## DRAINAGE AND TRANSPORTATION INFORMATION SHEET

**RE: Grading and Drainage Plan  
Haltom Dental**

DESIGNER'S SEAL  DAVID SOULE P.E. #14522	LAGRIMA DE ORO PARKING LOT DR. HALTOM OFFICE	DESIGN BY DSE 8-17-18
	GRADING AND DRAINAGE PLAN	SHEET # 1 of 1
 <b>Rio Grande Engineering, Inc.</b> 1000 CENTRAL AVENUE ALBUQUERQUE, NEW MEXICO 87102 (505) 263-2800		JOB # 20000

RE: **Haltom Dental**  
**10433 LaGrima Del Oro NE**  
**Grading and Drainage Plan**  
**Engineers Stamp Date 7/1/15 (F21D052)**

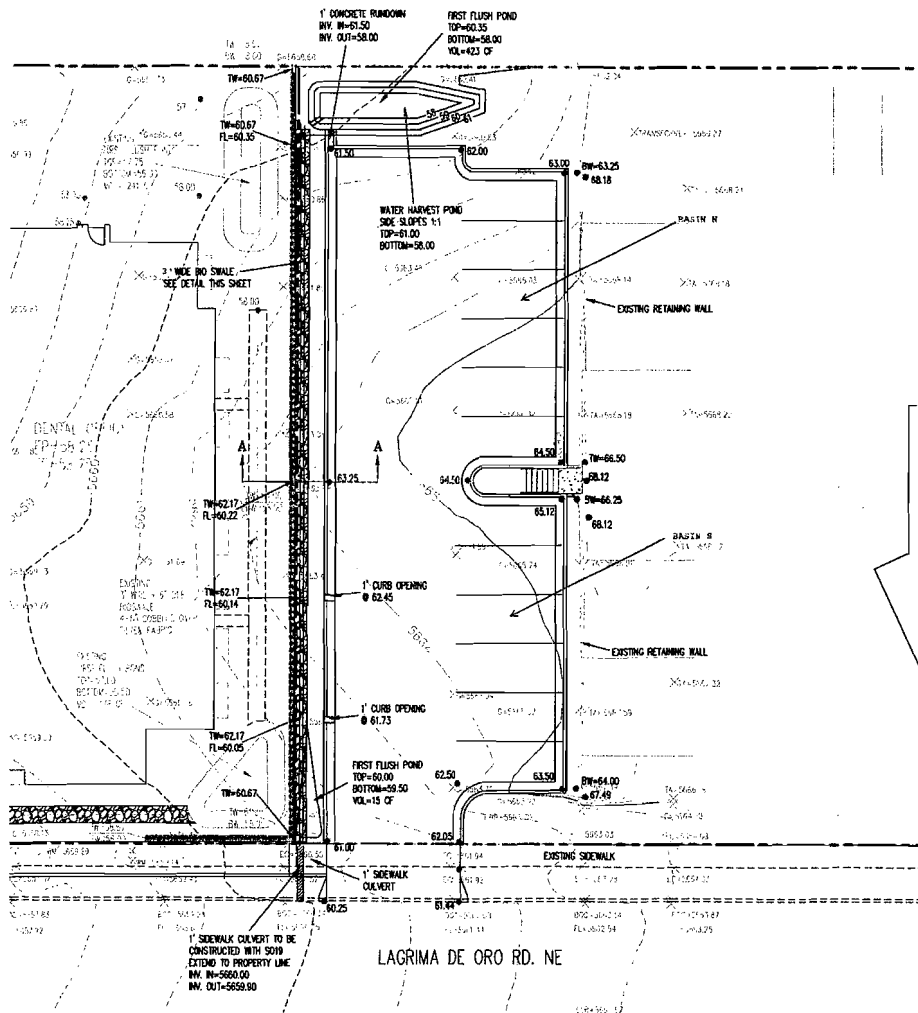
- Provide build notes on the G&D plan.
- Provide the benchmark.
- Provide a date on the signature line/remove X-XX-13.
- Provide a curb cut in the Southeast corner of parking lot.
- Depress all landscaping areas.
- Provide spot elevations along swale.
- Provide invert at beginning of swale.
- Show location of wall in Bio Swale Detail.
- Extend sidewalk culvert 2 feet inside property line.
